DEVIATION REQUEST AND DECISION FORM

Project Name :	Crossroads North
Schedule No.(s) :	5408001008, 5408001029, 5408001032, 5408001033, 5408001034, 5408001041, 5408001042, 5408001050, 5408001051, 5408001052
Legal Description :	LOTS 12, 13, 14, 15, 16 AND 18, HILLCREST ACRES, ACCORDING TO THE PLAT THEREOF RECORDED MAY 12, 1960 AT RECEPTION NO. 153860, EXCEPT THAT PORTION ACQUIRED BY THE DEPARTMENT OF TRANSPORTATION, STATE OF COLORADO AS DESCRIBED IN RULE AND ORDER RECORDED APRIL 28, 2004 UNDER RECEPTION NO. 204068322, AND EXCEPT THOSE PORTIONS CONVEYED TO EL PASO COUNTY BY AND THROUGH THE BOARD OF COUNTY COMMISSIONERS OF EL PASO COUNTY, COLORADO BY SPECIAL WARRANTY DEED RECORDED DECEMBER 17, 2014 AT RECEPTION NO. 214116021 AND RECORDED DECEMBER 17, 2014 AT RECEPTION NO. 214116022, COUNTY OF EL PASO, STATE OF COLORADO. LOT 17, HILLCREST ACRES, COUNTY OF EL PASO, STATE OF COLORADO, EXCEPT THAT PORTION CONVEYED TO EL PASO COUNTY BY AND THROUGH THE BOARD OF COUNTY COMMISSIONERS OF EL PASO COUNTY, COLORADO BY SPECIAL WARRANTY DEED RECORDED DECEMBER 30, 2014 AT RECEPTION NO. 214119767. LOT 19, HILLCREST ACRES, COUNTY OF EL PASO, STATE OF COLORADO, AS AMENDED BY SURVEYOR'S STATEMENT RECORDE

SCALE: NOT TO SCALE

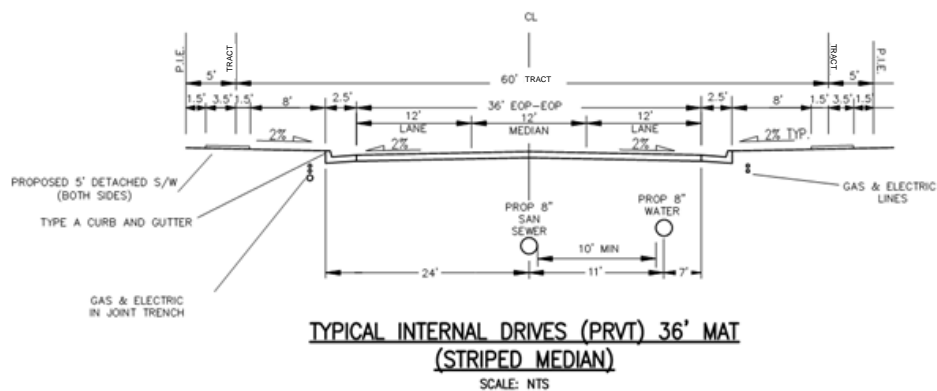
Please update the names as the prelim plan sheets and the grading plan road names do not match.

Additionally, only the east/west private roadway needs a deviation as the north/south roadway meets the standard urban non-residential collector roadway cross section per sheet 5 of the prelim plan. The LDC private road waiver allows for ROW width modification in LDC 8.4.4.E and it appears that that is the only change requested for the north/south roadway which is covered in the LDC waiver.

Revise the deviation to only include the roadway (east/west roadway) that is deviating from the standard. Per conversation with Engineering manager, staff is not against this deviation but information should be accurate. See comment below

Please clarify the tract width proposed as the prelim plan identifies an 80' easement for the north/south road and a 70' easement for the east/west road. revise as necessary for consistency.

update accordingly.
